RE: LPSC Docket No. I-34694. *Integrated Resource Planning (“IRP”) Process for Energy Louisiana LLC (“ELL”) Pursuant to General Order Dated April 20, 2012*

Dear Commissioners and Staff,

### **Disputed Item #1: Capacity-Only Planning is Deficient**

ELL's "Heuristic" Solar Capacity Assumptions

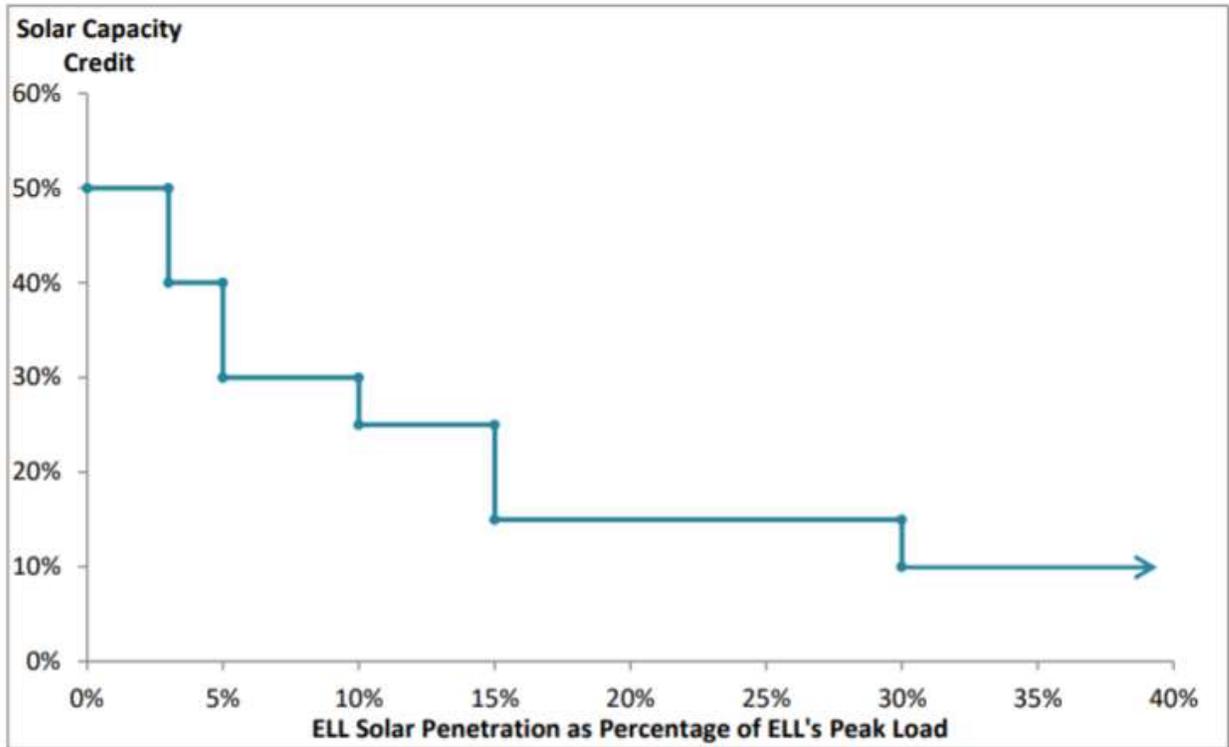
Further, ELL misrepresents MISO's work. ELL never cites where its "heuristic" concept is derived, but SREA is familiar with MISO's Renewable Integration Impact Assessment (RIIA) work. Currently MISO's RIIA is a work-in-progress and does not reflect an end-result, a final product, nor an adopted methodology by MISO. Even so, ELL's "heuristic" approach does not actually match MISO's own preliminary results. ELL's "heuristic" approach shows that solar power capacity credit would drop to approximately 10% at 30% penetration level of ELL's system. But MISO's RIIA results show that the effective load carrying capacity (ELCC) of solar power does not drop to 10% until after nearly 70,000 MW's of solar are added to the *entire* MISO system.

However, ELL’s “heuristic” approach to evaluating capacity value for solar power would radically change if energy storage and solar power were combined.

**Figure 2. Wind Farms Evaluated for LMP Differential Values, 5-minute increment**

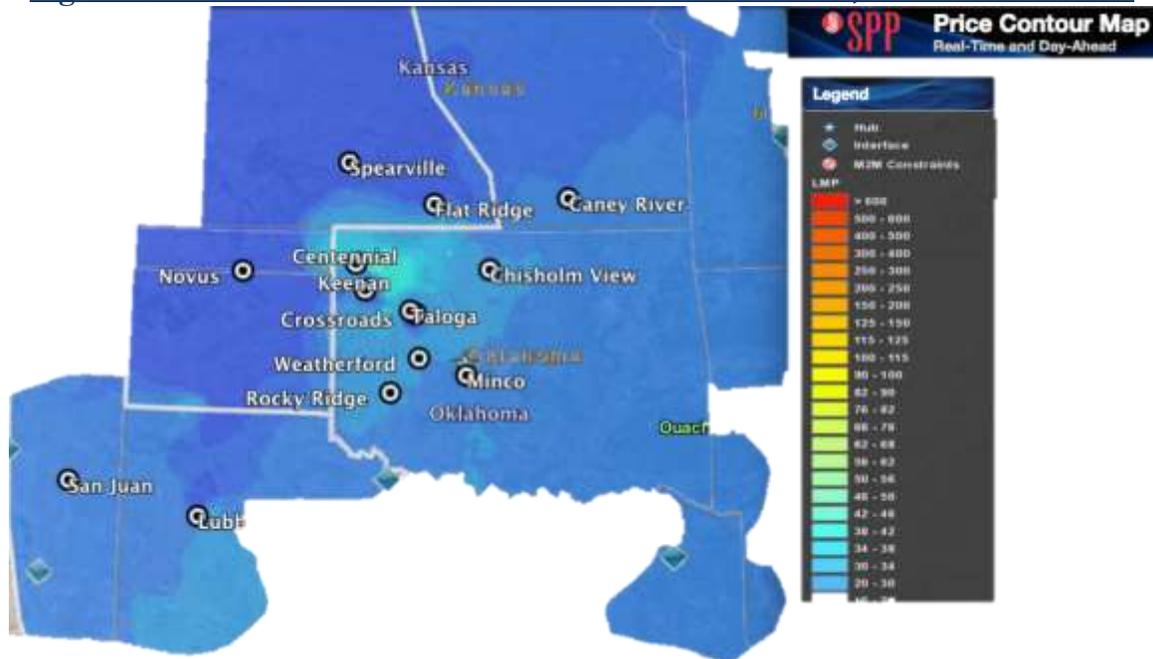
The three wind farms evaluated for the Final IRP (Spearville, Centennial and Keenan) are in some of the worst congested areas within SPP. As such, these three wind farms do not represent a fair analysis for LMP differentials. SWEA evaluated the three wind farms, in addition to eleven other wind farms within SPP. Figure 2 shows the fourteen total wind farms plotted against a recent LMP contour map from SPP.
